Facility Name: **Telfair Forest Products, LLC**

Permit No: 2499-271-0022-V-05-2

Addendum to Narrative

SIP CONSTRUCTION PERMIT AND TITLE V SIGNIFICANT MODIFICATION APPLICATION REVIEW

Figure 2: Graph from EPA’s Guidelines for Exposure Assessment

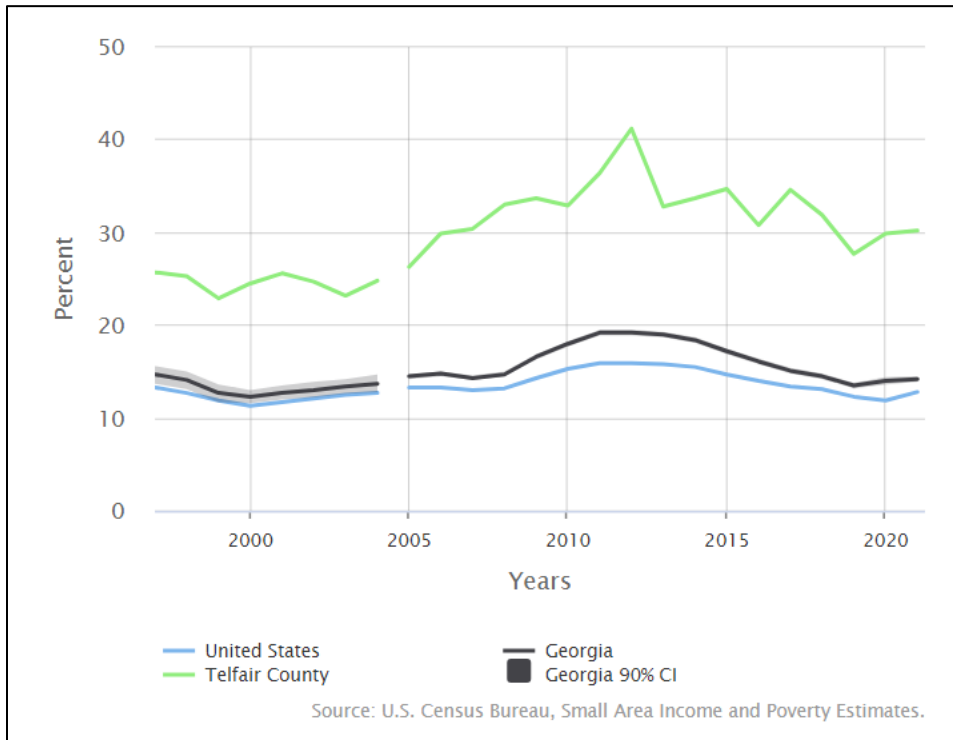
Telfair proposes to vastly increase its pollution next to a community that is predominately Black, has high rates of poverty, and has profound health vulnerability indicators, without analyzing the impact its increased pollution may have on this community. EPD can play an important role in ensuring that the health and safety of the population nearby is protected.

The Telfair facility is in the middle of Lumber City, which is estimated to have a population that is 72% Black with a median household income of less than \$29,000 a year. Furthermore, Telfair County has extremely high poverty rates compared to Georgia and the rest of the United States.

GA EPD does not select sites for facilities. When companies choose their proposed locations, they frequently also must obtain local permits or permissions to build and operate their facilities. GA EPD does not have oversight of these local government decisions. Current state and federal air quality requirements do not prohibit the increase of emissions or the installation of a new emission source based on the demographic makeup of the surrounding area. However, as discussed above GA EPD strives to provide opportunities for public feedback and as discussed below GA EPD conducted a thorough evaluation of the potential emissions impact on the air quality and the surrounding community.

GA EPD completes an independent analysis of the air emission impacts from proposed new emission units as well as the entire existing facility on the ambient air. These impact assessments model projected emissions using the protocols in the Georgia “Guideline for Ambient Impact Assessment of Toxic Air Pollutant Emissions.” Those protocols specifically factor in potential health impacts of those emissions on people living in the surrounding area. When GA EPD performed this analysis for the facility, it indicated that the HAP emissions from the facility, after the modification, would not pose a significant risk to the community.
